**Article No.  
96-13-7**

**FORD:** 1992-1995 BRONCO, F-150-350 SERIES, F-47

**ISSUE**

Figure 1 - Article 96-13-7

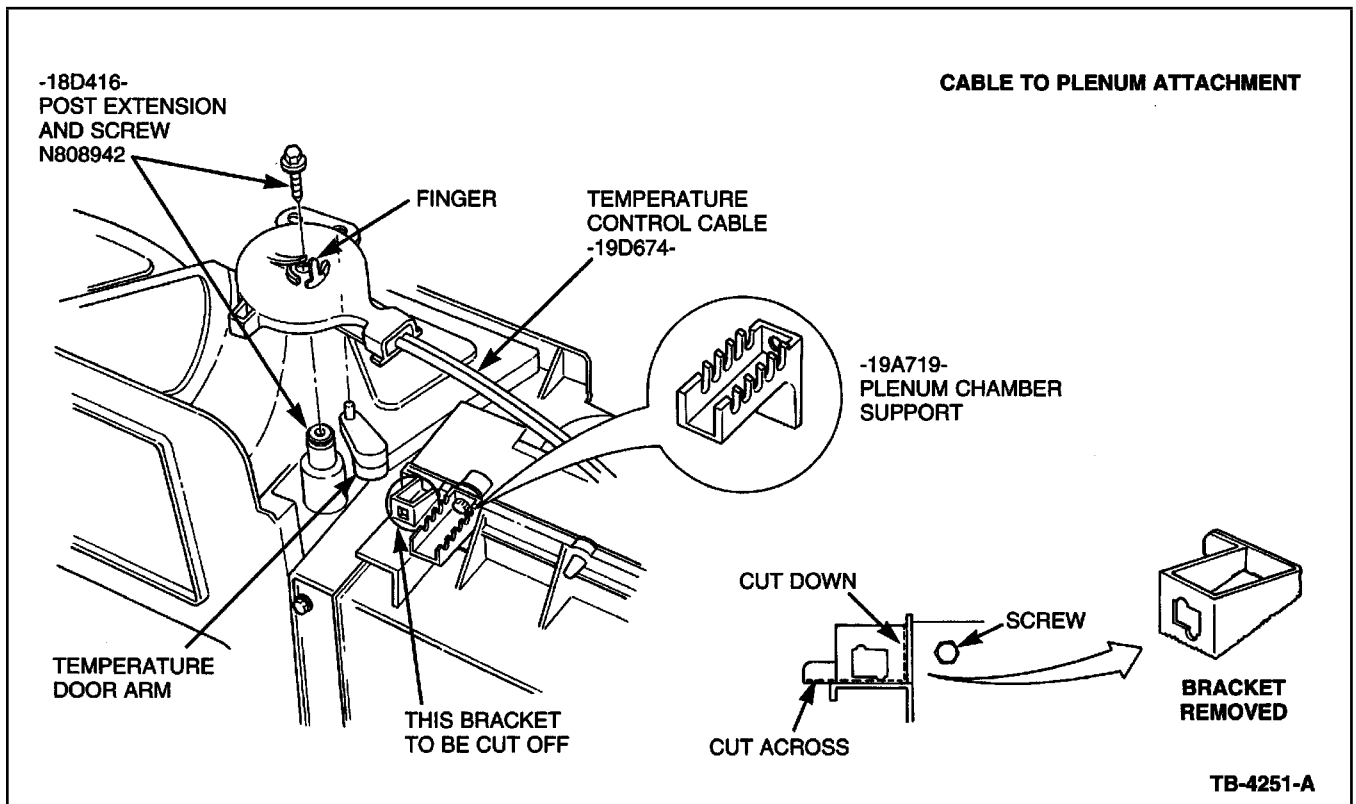
1. Remove glove compartment and module assembly, if present.
2. Detach cable from plenum using Tool D91T-18532-A. Remove and discard cable.
3. At the cable bracket on the plenum heater core cover, cut away the bracket using a hacksaw blade or similar tool. Refer to Figure 1.
4. Remove the 5/16" headed screw from the top of the cam. Discard the cam and screw with spring clip. Refer to Figure 2.
5. At cam post, add post extension and secure with the new screw, torquing the screw to 1.7 N•m (15 lb-in). Refer to Figure 1.

6. Remove the upper left screw securing the plenum heater core cover and install the A/C plenum chamber support bracket between the ribs to the right side of the bracket which was cut off. Make sure the hole from the previously removed screw is lined up with the hole in the plenum chamber support bracket. Refer to Figure 1.

1. At the plenum chamber, move the temperature door arm to the "full warm" position (counterclockwise) and be sure it remains there throughout the installation procedure. Refer to Figure 1.

4. At the plenum, position the cam end of the cable over the post. Make sure the temperature door arm can move into the slot of the cam and push down until the cam is engaged on the post. An audible click can be heard. If it is necessary to remove the cam cable head, use moderate finger pressure on the plastic tab at the top of the cam cable head, moving it back so the cam may be pulled out off the post. Refer to Figure 1.

5. Place the twin cables in the center slots of the A/C plenum chamber support bracket. If adjustment is needed later, the cables can be moved to the other adjacent slots. Refer to Figure 1.

Figure 3 - Article 96-13-7

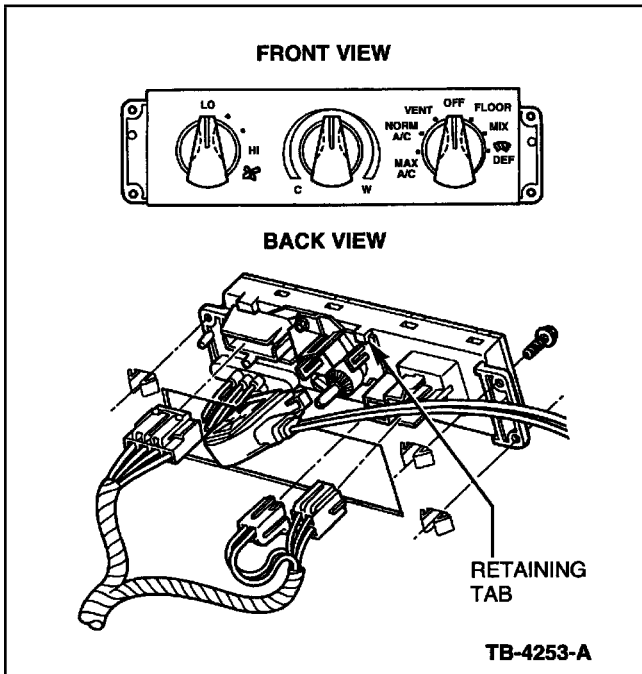
2. At the small end of the cable (control head), remove the temperature control bracket from the cable by releasing the three (3) snaps using Tool T94P-18532-A or a thin blade screwdriver to allow the cable to be pushed back through the instrument panel toward the control head. Refer to Figure 3.

8. Push the temperature control bracket onto the control assembly and turn it to catch under the retaining tab. Secure with the new screw previously saved. Refer to Figure 3.

9. Place the knob on the temperature control.
10. Push the cable head onto the temperature control bracket (make sure gear pilot centering hole is lined up correctly) until the three (3) lock into position (you should hear a click of three (3) tabs). Refer to Figure 3.
